Re: St. Lucie Plant Unit 1
Docket No. 50-335
Renewed Facility Operating License No. DPR-67

Response to NRC Nuclear Performance and Code Review Branch Request for Additional Information Regarding Extended Power Uprate License Amendment Request

Response to Request for Additional Information

Figure 1

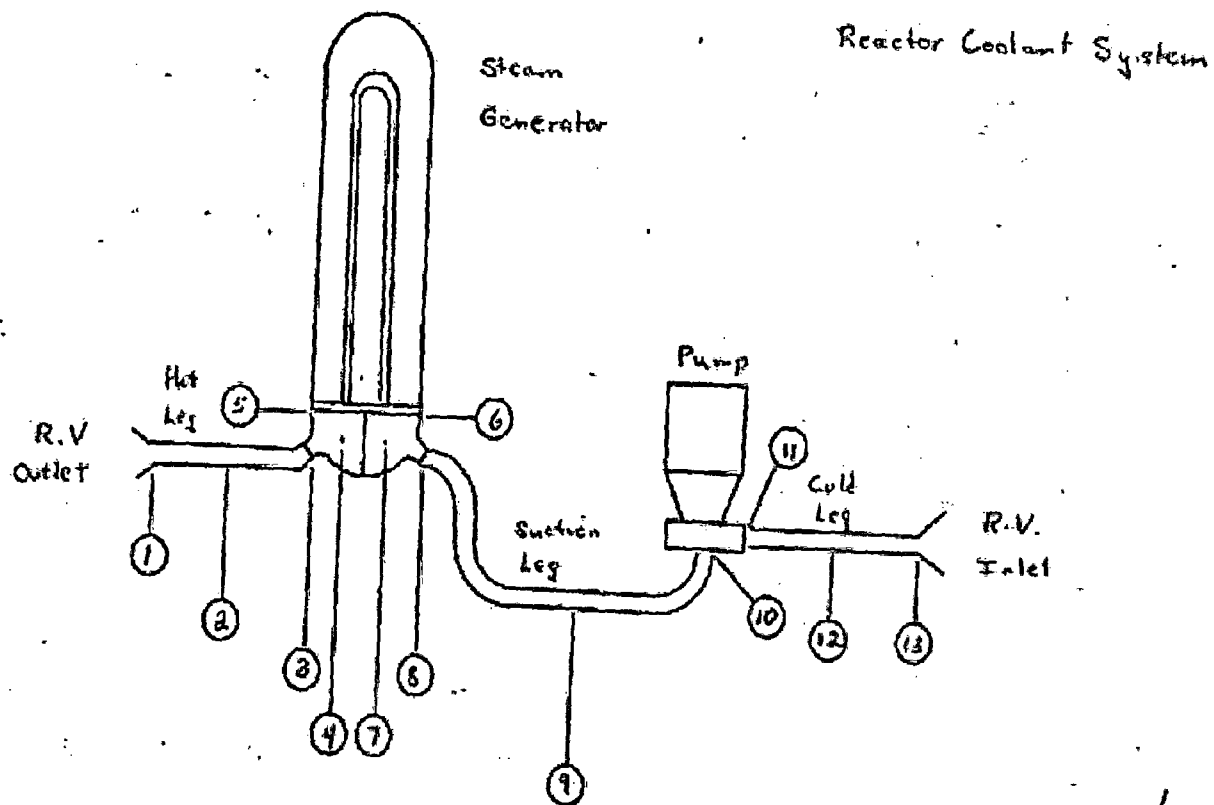
- b. Loop friction and geometry pressure losses from the core exit through the steam generators to the inlet nozzle of the reactor vessel. Also, provide the locked rotor RCP k-factor. Please provide the mass flow rates, flow areas, k-factors, and coolant temperatures for the pressure losses provided (upper plenum, hot legs, SGs, suction legs, RCPs, and discharge legs). Please include the reduced SG flow areas due to plugged tubes. Please also provide the equivalent loss coefficient through the loop to a break in the single broken cold leg. Also identify the flow area (hydraulic diameter) the k-factors are based on.**

- b. The loop friction and geometry pressure losses requested in Part B are documented below in Tables 2 through 4, along with Figures 1 and 2, which are provided for informational purposes. Additionally, Table 2 and Figure 2 provide information on the reactor vessel, which was not specifically asked for, but provided for completeness.

Table 3
Calculation of Loop Station-to-Station K-Factors Excluding SG Sections (Figure 1)

Table 4					
Calculation of SG Station-to-Station K-Factors (Figure 1)					
Section	Flow Area (ft²)	Kf (Asg)	Kg (Asg)	Kf* (Acore)	Kg* (Acore)
3-4	9.62	0	0.484	0	18.301
4-5	18.22	0	0.34	0	3.584
5-6	18.22	0.0128	0.16	126.793	1.687
6-7	18.22	0	0.47	0	4.954
7-8	9.82	0	0.09	0	3.266

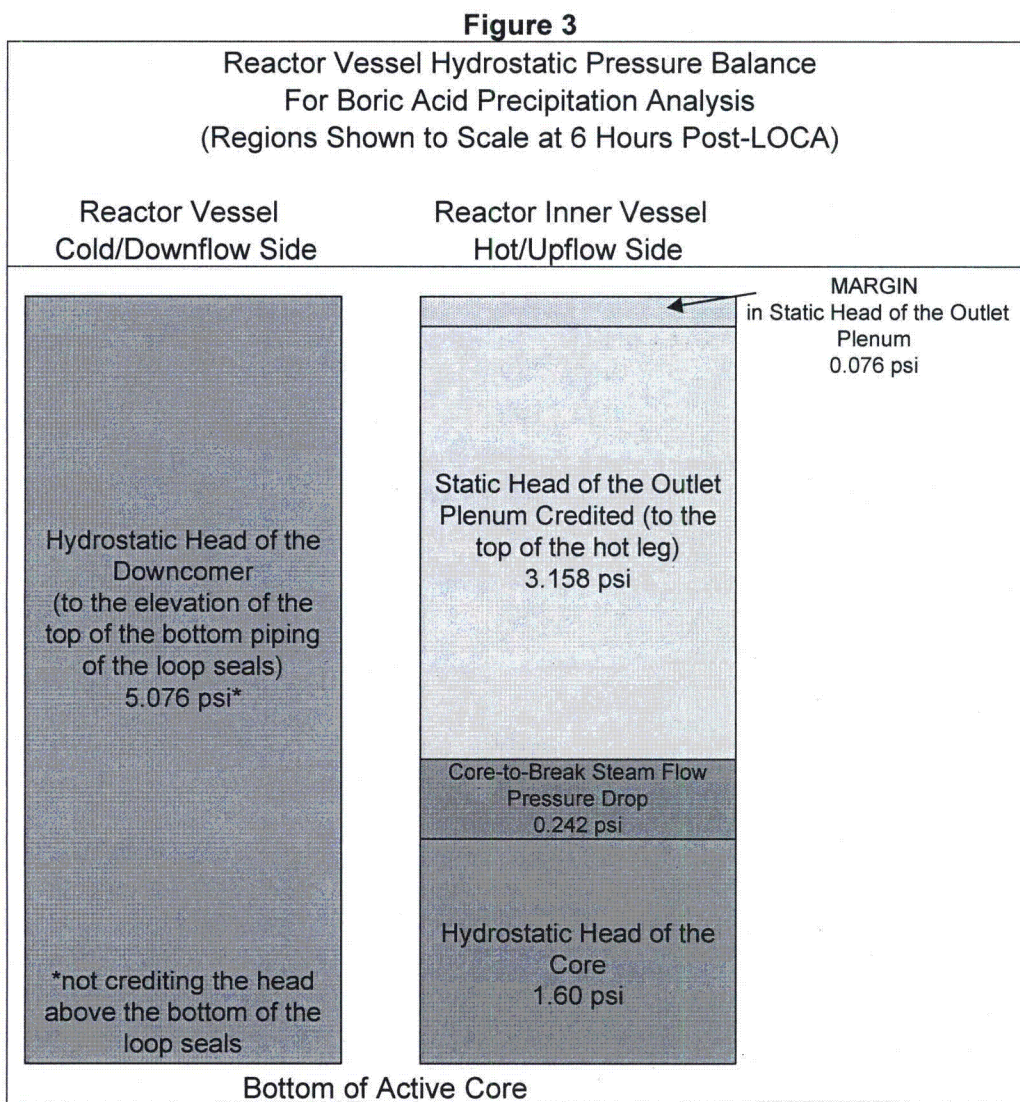
What is the effect of axial power shape on precipitation timing? Bottom peaks reduce the liquid inventory in the mixing volume. Please provide the most bottom skewed axial power distribution.

To evaluate the impact of bottom peaked shapes, using a more conservative version of the St. Lucie Unit 1 Cycle 24 bottom peaked axial power shape with ASI equal to +0.2, the mixing volume calculation was recalculated. Using this power shape resulted in a 1% reduction in the mixing volume. This is expected to have a negligible effect on the results of the boric acid precipitation analysis. The bottom peaked axial power shape used for this calculation is documented below:

Mixing Volume Region*	Height (feet)	Axial Peaking Factor
1	10.1875	0
2	1.1392	1.2
3	1.1392	1.3
4	1.1392	1.3
5	1.1392	1.2
6	1.1392	1.1
7	1.1392	1.0
8	1.1392	0.9
9	1.1392	0.8
10	1.1392	0.7
11	1.1392	0.5
12	7.6	0
